James Bay Neighbourhood Association

Re: 561-565 Toronto Street

Re: Development Proposal for 561-565 Toronto Street

Dear Honorable Mayor and Council, <u>Re: Development Proposal for 561-565 Toronto Street</u>

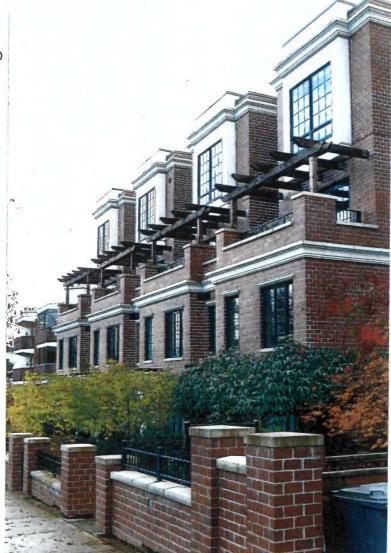
I had used drawings, photos and ideas to encourage the developer to break up his box-like proposal with an articulation of vertical bays containing balconies within the building envelope. These projecting bays are a reflection of existing house patterns on the Toronto streetscape.

These bays would be terraced at the second or third floor levels. The upper floors being setback a minimum of 2 meters in order to provide a welcome relief from the dramatic four storey cliffedge drop.

This modulation of building massing and setback responds to the fact that there is a municipal zoning change which divides the south side of Toronto Street from the north side with a significant difference in density, height and size.

The photograph to the right is an illustration of an appropriate application of Design Guidelines for this planning issue.
